Access Compliance Report

Public Rights-of-Way

Intersection ID: 43497	Main Street: DALTREY_LN	Cross Street: CARANNA_CT	Location: SW
ADA ID: 0C5D2010BE4D	Ramp Type: PerpDiag	Initial Pass/Fail: Fail	Overall Compliance: No
		Severity Score: 21.25

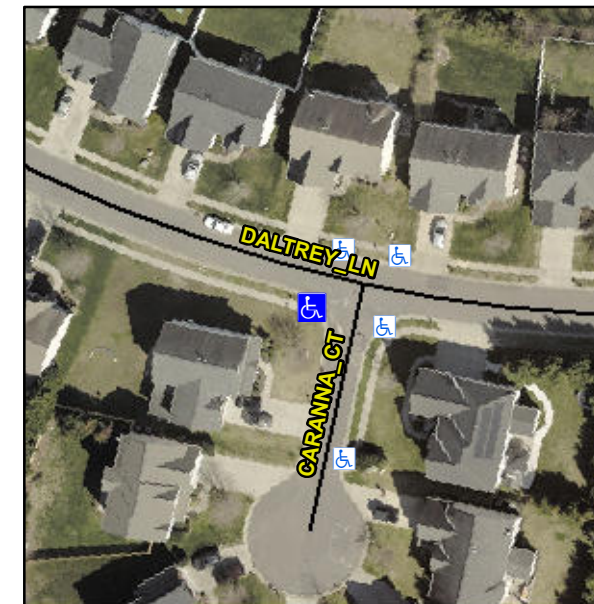
Not Found, R304.5.1, R304.5.3

Compliance	Description	Data	Compliance	Description	Data
N/A	Ramp Length (in)	51.0	Yes	Ramp Slope (%)	6.5
No	Ramp Width (in)	38.0	No	Ramp XSlope (%)	6.7
N/A	Flare Type LT	N/A	N/A	Flare Type RT	N/A
N/A	Flare Slope LT (%)	N/A	N/A	Flare Slope RT (%)	N/A
N/A	Flare Traversable LT?	N/A	N/A	Flare Traversable RT?	N/A
N/A	Landing Length (in)	N/A	N/A	DWS Provided?	N/A
N/A	Landing Width (in)	N/A	N/A	DWS Contrast?	N/A
N/A	Landing Slope (%)	N/A	N/A	DWS Length (in)	N/A
N/A	Landing X Slope (%)	N/A	N/A	DWS Full Width?	N/A
N/A	Landing Curb? (Y/N)	N/A	N/A	DWS Offset (in)	N/A
N/A	Shared Landing?	N/A			
N/A	Gutter Ponding?	N/A	N/A	Gutter Slope (%)	N/A
N/A	Gutter Lip Ht (in)	N/A	N/A	Gutter X Slope (%)	N/A
N/A	Painted X Walk1?	No	N/A	Painted X Walk2?	No
	X Walk 1 Direction	To SE		X Walk 2 Direction	To NE
N/A	X Walk 1 Width (in)	N/A	N/A	X Walk 2 Width (in)	N/A
	X Walk 1 Slope (%)	2.6		X Walk 2 Slope (%)	3.4
	X Walk 1 X Slope (%)	3.2		X Walk 2 X Slope (%)	2.1

Remove & Replace Curb Ramp With Two New Directional Ramps or Equivalent.
